PROPOSAL EVALUATION TRANSMITTAL PCO 008

Date: October 2, 2014
Sent via: Fax U.S. Mail UPS E-mail Hand
To: Robert Griffith **Project #:** 12018
Firm/Agency: SUHSD **Project Name:** Summerville High School Modernization
Address: 17555 Tuolumne Road **File No.:** 55-H2/ 02-113454
City, State, Zip Tuolumne, CA 95379 **CC:** REB Construction
From: Mark Damrel Mike Martin (IOR)
Phone: (408) 588-3819

Date	Proposal No.	Description
09/16/14	PCO 008	RFI 019: added brackets at scoreboard column

Subject: Scoreboard mounting
Discipline:
Specification Section Title:
Section Number:
Page:
Sheet Number:

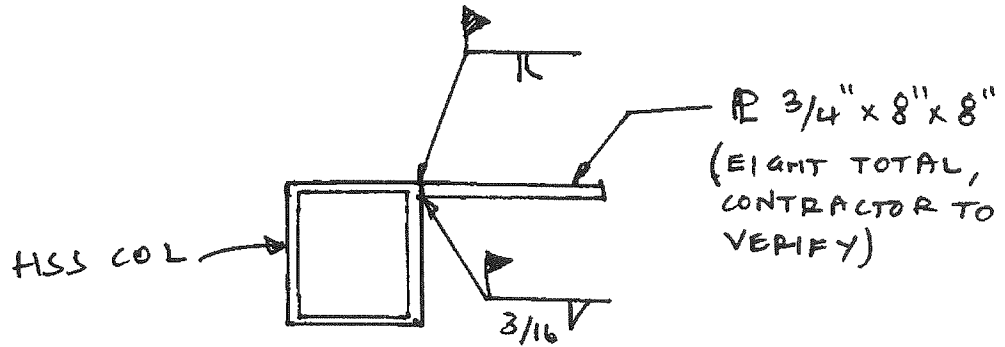
Per survey, the scoreboard 6x6 columns were set at 14' to center. The manufacturer's recommendation is for "I" Beams set at 13' to center and to be attached by a "J" Bracket. We will need to modify the current 6x6 posts in order to mount the scoreboard using the J brackets already installed on the scoreboard. Please advise on how to proceed with this modification. Our suggestion would be to weld an "ear" in 4 locations that align with the "J" brackets and would allow us to bolt the scoreboard through the new "ear". Attached are the drawings from the manufacturer. Please advise.

ADD PLATES PER ATTACHED DETAIL.

1. CONTRACTOR SHALL INSTALL HOLES PER MFR'S CONNECTION CLIPS. HOLES SHALL BE DRILLED AND NOT TORCH-CUT.
2. HOLES SHALL HAVE $1\frac{1}{2}$ " MIN EDGE DISTANCE AT ALL SIDES.
